> Watts Bar Nuclear Plant, Unit 2 NRC Docket No. 50-391

Subject: Watts Bar Nuclear Plant (WBN) Unit 2 - Denial of Notice of Violation (NOV) 05000391/2010603-08, Failure to Adequately Evaluate and Qualify Molded Case Circuit Breakers

1. WBN Unit 2 Reply to NOV 05000391/2010603-08

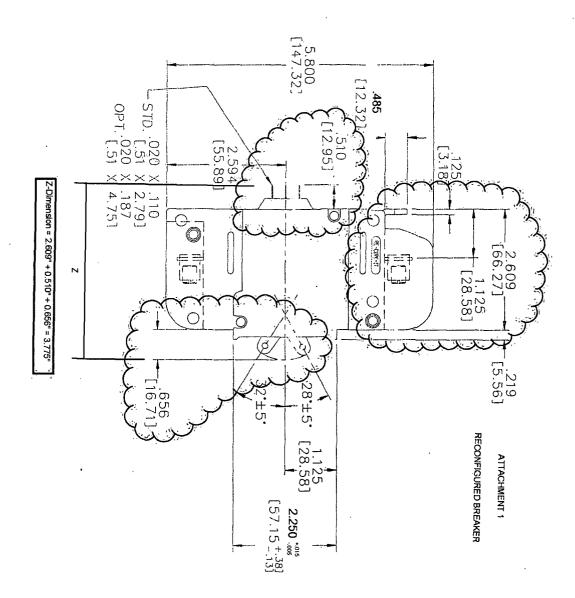
Some confusion during the NRC's inspection was created by information contained in the 1992 qualification report. The 1992 qualification report indicated a Z dimension of 3.75" and the manufacturer's catalog now indicates 2.609" for the critical characteristic. There is an explanation for the difference.

- Vendor schematics show the Z dimension of 3.75" given in the 1992 qualification report includes the depth of the main body of the breaker of 2.609" plus the dimension from the rear body of the breaker to the end of the auxiliary contacts (0.510") plus the dimension from the front body of the breaker to the end of the lever (0.656") (reference Attachment 1 and 2 in this Enclosure). The total dimension is 3.775" at the maximum arc of the breaker arm and is less than 3.775" in the closed or open position. The clamping depth of the breaker as installed in the power board is 2.8509" (2.609" + 0.25"). The depth (2.609") of the main body of the breaker is the same for the original and the reconfigured breaker. Therefore, the purpose of the 0.25" thick Micarta plate is to maintain the required clamping depth for the reconfigured breaker.

- In calculation WCG-ACQ-1004 the change in mounting depth of the breaker was recognized and the change with the addition of the Micarta plate was evaluated.

NRC stated that the breaker was modified by attaching a Micarta plate to the rear of the breaker using 4 nuts and bolts to fit them in the power boards, as described in Example 1, without updating the qualification package. However, the qualification package includes calculation WCG-ACQ-1004, which addresses the qualification of the circuit breakers with the Micarta plate and concludes that the component (i.e., circuit breaker) remains seismically qualified under like for like conditions per the 1992 seismic qualification device test. Since breaker clamping configuration was improved by creating a larger contact surface between the breaker and the rear angle irons which makes it more stable when secured by the front cover and the change in breaker weight was minor, the seismic qualification of the overall board was not affected.

Calculation WCG-ACQ-1004 analyzed the effects that were introduced by the modification, demonstrated an adequate review for suitability of application, and analyzed the impact on other components.

Calculation WCG-ACQ-1004 was prepared to qualify the new Heinemann breakers that will replace existing breakers located in the 120 VAC Vital

Instrument Power Boards. The methodology of the calculation was to address maintaining the seismic qualification of host equipment with the replacement of existing components.
